MEMORANDUM

FROM: Chuck Lesniak, Environmental Officer

SUBJECT: Austin Oaks Planned Unit Development – C814-2014-0120

Attachment C Austin Oaks PUD Site Photos

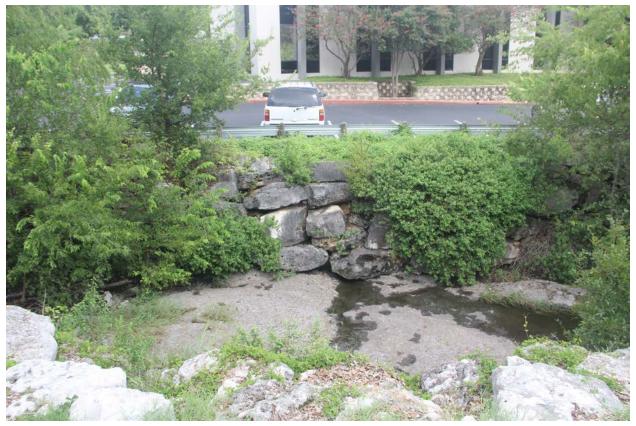
View of creek and parking lots within the CWQZ and CEF buffer

Portion of west creek bank area to be restored
